ADDENDUM NO. 02

February 8, 2023

Franklin Central High School Addition & Renovations
6215 S. Franklin Rd.
Indianapolis, IN, 46259

DATE: February 7, 2023
PROJECT: Addition & Renovations to Franklin Central High School
OWNER: Franklin Township Community School Corporation
PROJECT NO.: 2022043.00

Exhibit A – Blocking & Sheathing – Typical Scope Reference

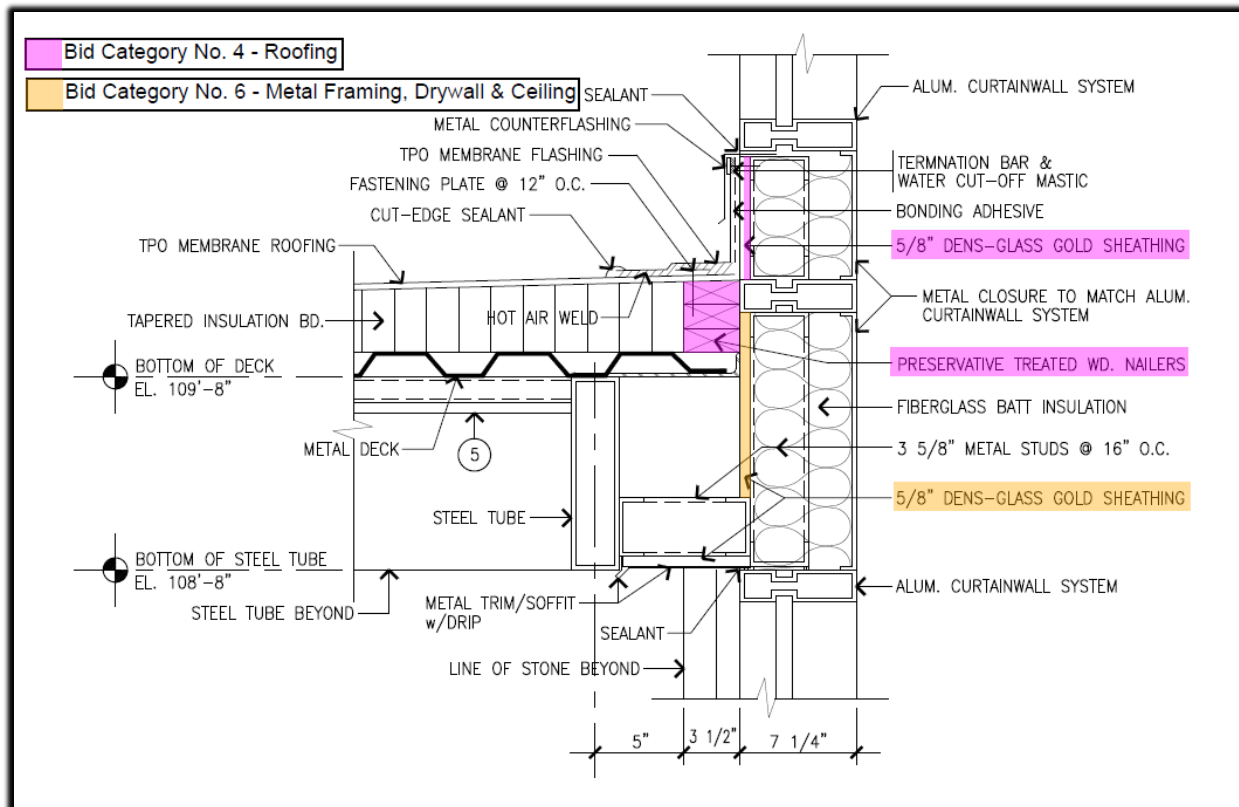
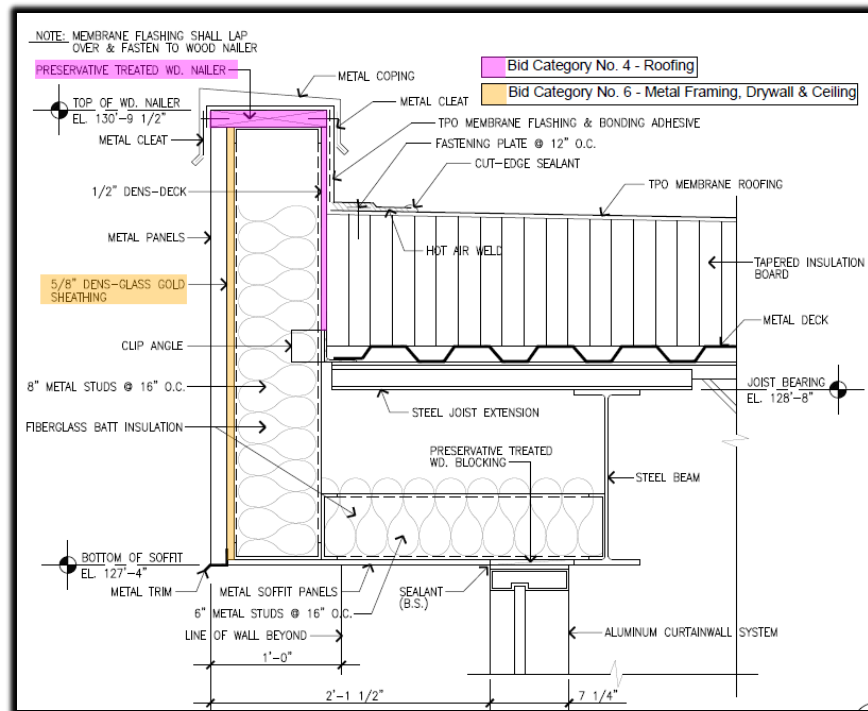
26. Bid Category No. 4 to provide sheathing where direct adhered to TPO. Reference (Addendum 2) – Exhibit A for typical reference of blocking and sheathing within the roof system provided by Bid Category No. 4.

5. Provide Dens Deck sheathing where direct adhered TPO is required.
6. Reference (Addendum 2) – Exhibit A for typical reference of blocking and sheathing within the roof system required per Project Specific Clarification No. 3 of this bid categories scope of work.

4. Bid Category No. 4 to provide sheathing where direct adhered to TPO. Reference (Addendum 2) – Exhibit A for typical reference of blocking and sheathing within the roof system provided by Bid Category No. 4.
